Subject: UniStar Nuclear Energy, NRC Docket No. 52-016
Response to Request for Additional Information for the
Calvert Cliffs Nuclear Power Plant, Unit 3,
RAI 368, Foundations

**Response to NRC Request for Additional Information
RAI No. 368, Question 03.08.05-10,
Foundations,
Calvert Cliffs Nuclear Power Plant, Unit 3**

RAI No. 368

Question 03.08.05-10

FIGURE 1: SETTLEMENT PROFILES ACROSS X-AXIS AT NUCLEAR ISLAND COMMON BASEMAT

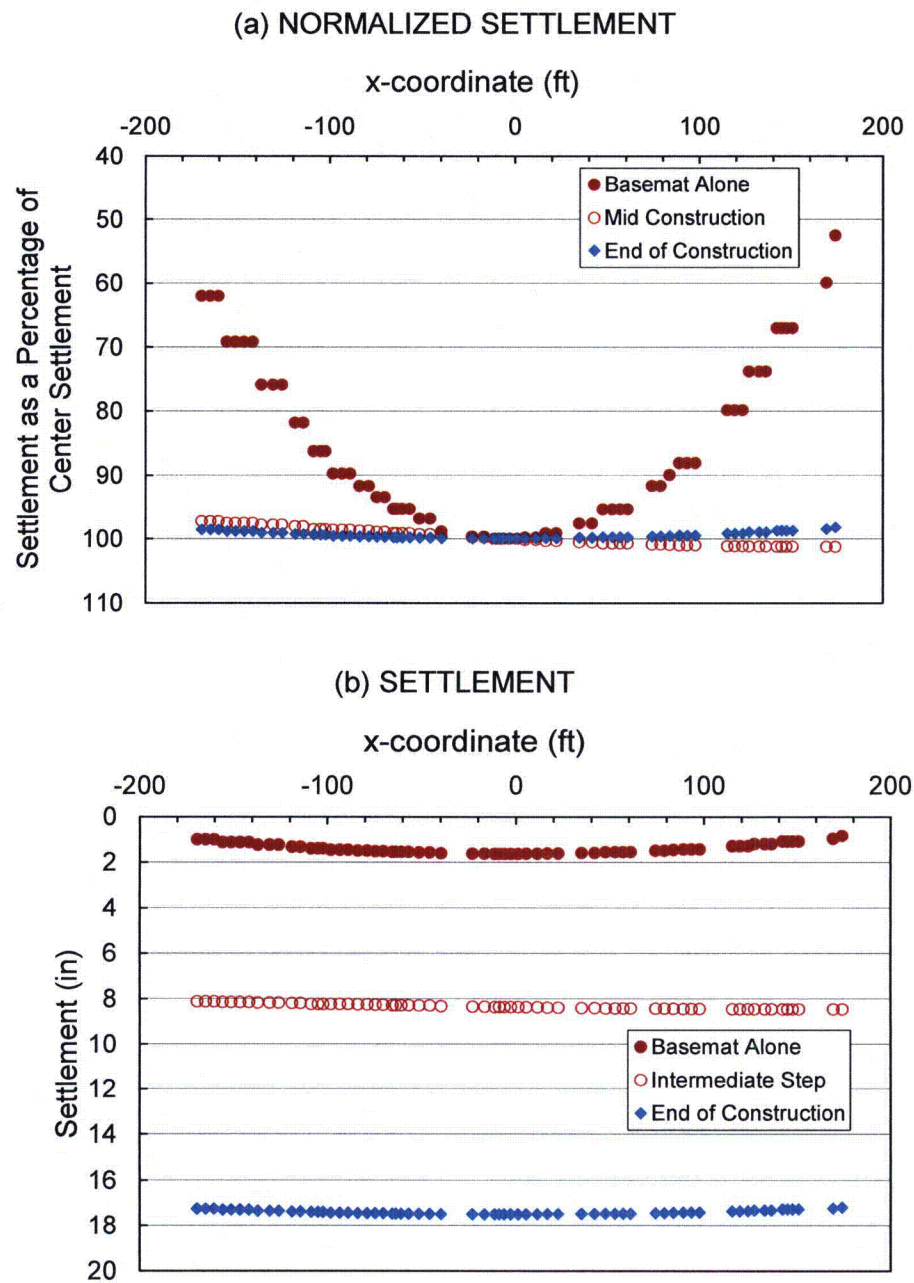
(1). Regarding the analysis procedure, U.S. EPR Revision 3 Section 3.8.4.5.2 indicates that two sets of soil springs are developed using Plaxis 3D foundation software. The first set of soil springs is developed with the geometry and loading of the basemat alone, corresponding to the first step of the construction sequence. The second set of soil springs is developed with the geometry and loading of the full NI common basemat structure, corresponding to the last step of the construction sequence. Each set of soil springs is developed by iterating on settlement results between a full 3D finite element structural model with soil springs and a Plaxis 3D model. The set of soil springs which controls the design of forces and moments due to settlement is used in 3D FE structural models for the design. The staff understands that iteration processes are performed for the first and last construction steps, two different sets of soil springs are obtained and the controlling set of soil springs is used for the design. The staff requests that the applicant explain why iteration process to determine soil springs was not done for intermediate construction steps in the site-specific settlement analysis of the NI common basemat structure.

The end of construction case is considered to be most critical in terms of overall settlement and tilt. The basemat case is considered to be most critical in terms of flexure. Initially, iterations were conducted for only the basemat and end of construction cases. To verify that these cases represent bounding conditions, the settlement reconciliation analysis has been repeated for another construction step at about 500 days or when the construction of the Nuclear Island (NI) common basemat area approximately reaches plant grade elevation. This step is referred to as the intermediate construction step.

For the intermediate construction step, the settlement reconciliation between the structural ANSYS model and the geotechnical PLAXIS model was performed in an equivalent form, and the difference in settlement between both models is less than 3.5%. For the reconciliation, the elements below the grade in the NI common basemat are considered.

A comparison of settlement results between the basemat, intermediate, and end of construction cases, for two axes that cross the NI common basemat, is provided in Figure 1 and Figure 2. Figures 1a and 2a present results normalized to the settlement of the center point and Figures 1b and 2b provide the actual settlement values. The normalization allows for a better examination of the flexure behavior. As expected, the largest flexure occurs for the basemat case, whereas the end of construction case resembles the rigid body rotation. The intermediate step settlement profile is between the basemat and end of construction cases, in terms of overall settlement magnitude and tilt.

As previously indicated, settlements control the design forces and moments, and springs are used to model accurate settlements. The springs for basemat and end of construction cases used in the settlement reconciliation analyses represent the most critical cases in terms of settlements. As shown, settlements for the intermediate construction case fall between the settlements for basemat and end of construction cases, in terms of overall settlement magnitude

**FIGURE 3: SHEAR WAVE VELOCITY DISTRIBUTION ACROSS THE NUCLEAR ISLAND
COMMON BASEMAT**

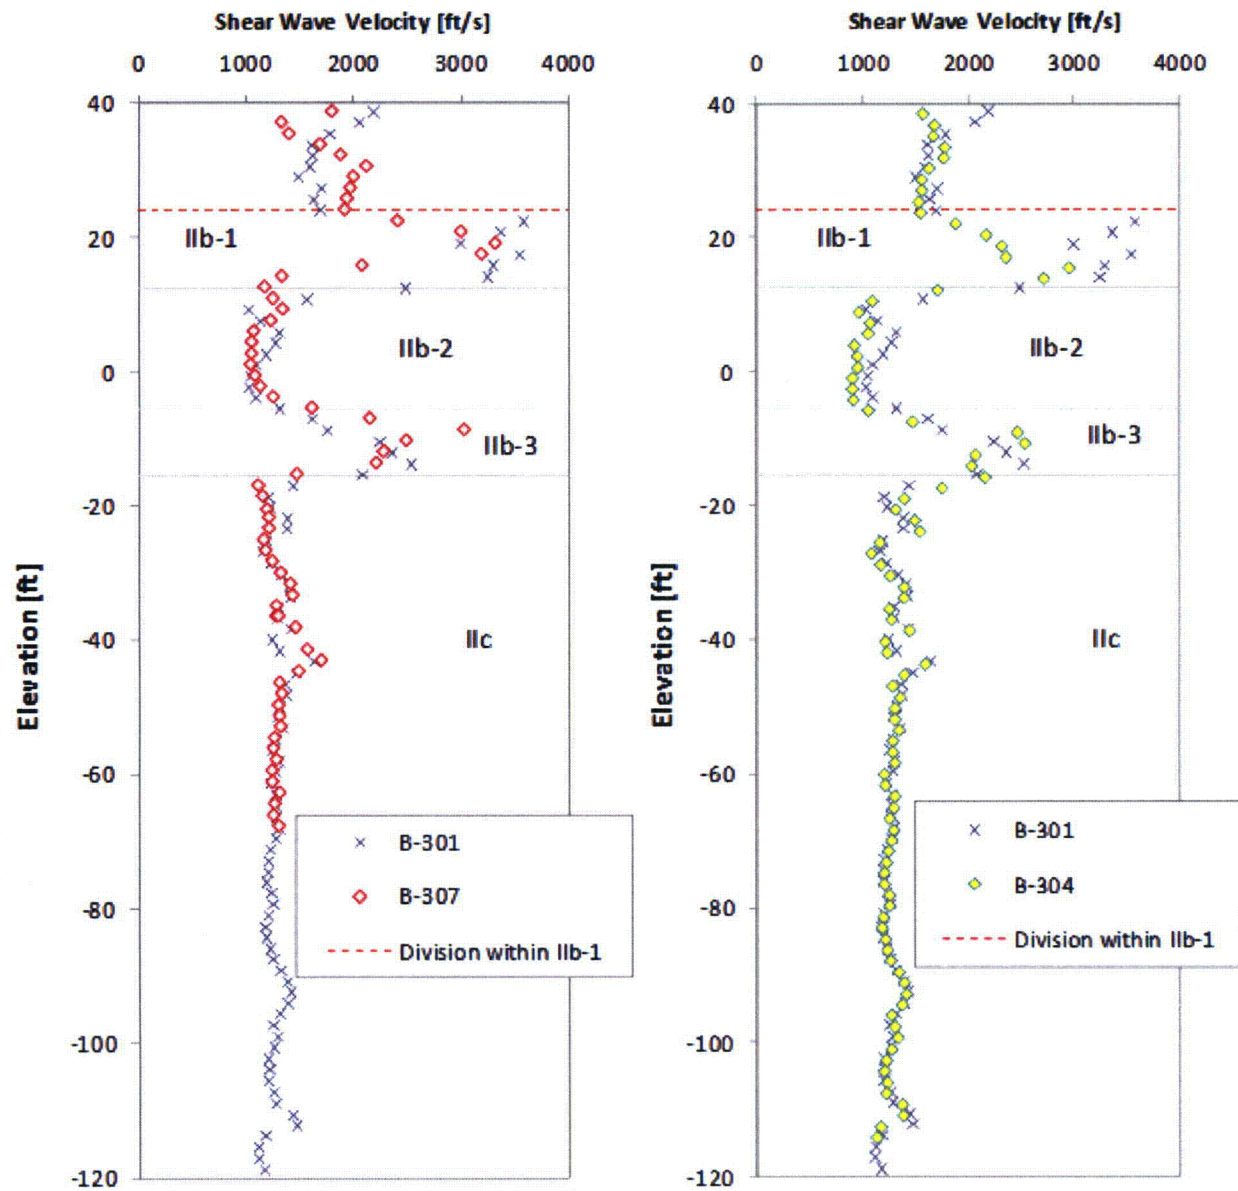
(3). As discussed before, the U. S. EPR settlement analysis of the NI common basemat structure considers a sandy material with laterally uniform soil stiffness. It is not clear to the staff whether the analysis considers all the site-specific conditions discussed in CCNPP Unit 3 FSAR Revision 7 Section 2.5.4.10.2. Therefore, the staff requests that the applicant explain in detail how each of the site-specific conditions discussed in Section 2.5.4.10.2 is considered in the site-specific settlement analysis of the NI common basemat structure. If not considered, provide the technical justification in detail for not doing so. Particularly, among the site-specific conditions, lateral variation of soil properties has significant effect on the differential settlement and hence the resulting member forces of a foundation mat. Consequently, the SRP Acceptance Criteria 3.8.5.II.4 discusses the review of the stiff and soft spots evaluation in the foundation soil to maximize the bending moments used in the design of the foundation mat. According to the response to RAI 276 Question 02.05.04-29, the coefficient of variation (COV) of shear wave velocity (V_s) measurements within Stratum IIb is as high as 0.4, and the COVs of V_s at certain elevations of Strata IIc and III are higher than 0.1. Furthermore, CCNPP Unit 3 FSAR Revision 7 Section 2.5.4.2.5.5 indicates that the values of soil elastic modulus utilized in the site-specific settlement analysis are also based on pressuremeter testing data and corrected SPT N-values, which both have high variation. The effect of the variation discussed above may be insignificant for overall settlement, but can be significant for differential settlement of the NI common basemat. Therefore, the staff requests that the applicant explain in detail whether and how the effect of the lateral variation of soil properties within a subsurface stratum has been considered in the site-specific settlement analysis of the CCNPP Unit 3 NI common basemat structure. If not done, provide the technical justification for not doing so. Since soil stiffness also depends on Poisson's ratios and soil densities, provide information on lateral variation for each of these parameters, including the supporting data based on field tests.

The lateral variability of shear wave velocity clearly supports the lateral uniformity of stiffness properties across the Nuclear Island common basemat. Even though comparison on the basis of equal elevation reveals isolated spots where some degree of variation is observed, this variation is expected, as dipping of cemented sand (Stratum IIb) layers occurs in the subgrade. In other words, if shear wave velocities are compared at an equal elevation plane, some locations may be in the cemented sand layer while others may not.

In order to correlate the distribution of shear wave velocity to the stiffness behavior across the NI common basemat, shear wave velocity is evaluated for a given layer for each boring. The statistics for shear wave velocity obtained as such are shown in Table 1, and indicate acceptable uniform subsurface conditions within the NI common basemat.

⁽²⁾ Data from Layer IIb-1 was subdivided into two groups, A and B, separated at Elev. +24 ft for a meaningful comparison (See Figure 3)

**FIGURE 4: SETTLEMENT MONITORING POINTS FOR NUCLEAR ISLAND COMMON
BASEMAT**

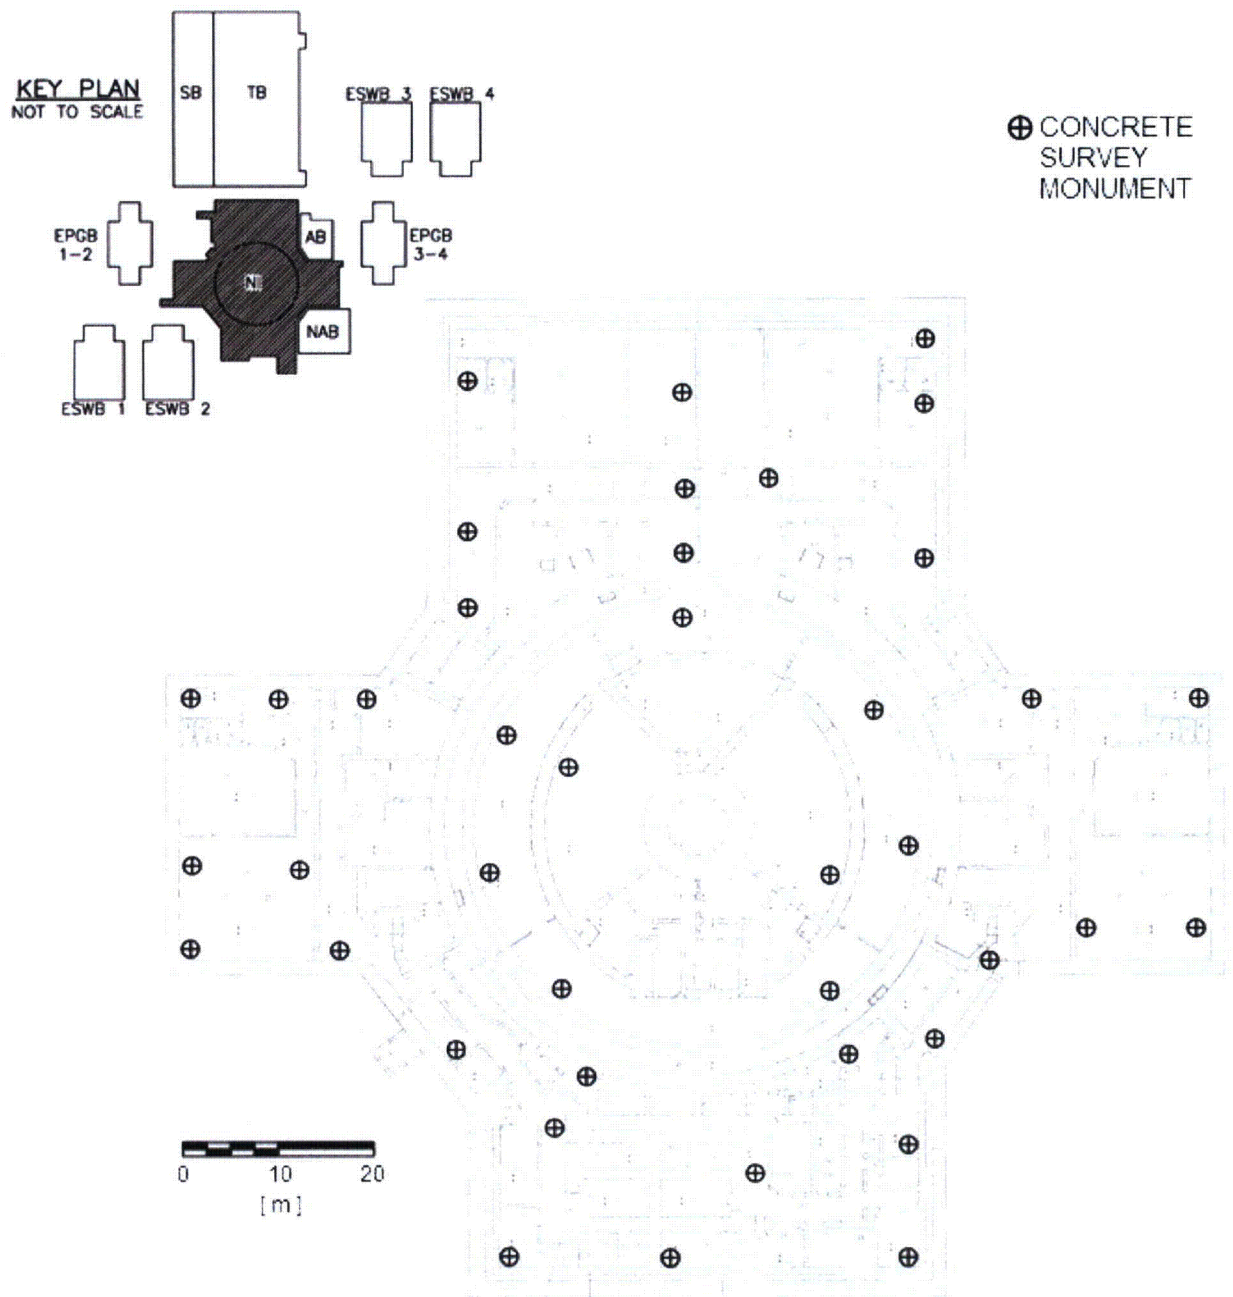
(4). In addition, to ensure that structural settlements during and post construction will be within the design envelop, so as to ensure the adequacy of the structural design, the updated U.S. EPR Tier 2 Table 1.8-2 COL Item 3.8-13 requires that CCNPP identify site-specific settlement monitoring requirements for Seismic Category I foundations based on site-specific soil conditions. For the NI common basemat structure, the settlement to be monitored includes the overall settlement, tilt, as well as differential settlements as per U.S. EPR Tier 2 Table 1.8-2 COL Item 3.8-18. CCNPP Unit 3 FSAR Revision 7 Section 3.8.5.7 describes a site-specific settlement monitoring program, and Section 2.5.4.10.2.2 provides more details of the program. However, based on the information provided in the FSAR, the staff cannot determine that the settlement monitoring program identified in the CCNPP Unit 3 FSAR Revision 7 is capable of providing the NI common basemat differential settlement contours similar to those described in the COL Item 3.8-18. To ensure that the COL Item 3.8-13 is adequately addressed, the staff requests that the applicant explain how the settlement monitoring program described in CCNPP Unit 3 FSAR Revision 7 Sections 2.5 and 3.8 is capable of providing the NI common basemat differential settlement contours similar to those described in U.S. EPR FSAR. Otherwise, identify a more detailed site-specific monitoring program, and revise the FSAR accordingly.

Additional settlement monitoring points are proposed as shown in Figure 4. The number of settlement monitoring points is sufficient to check against the predicted settlements. The final location of the monitoring points is subject to modification to adjust for construction limitations. However, the number and distribution of points will be similar to those proposed in Figure 4.
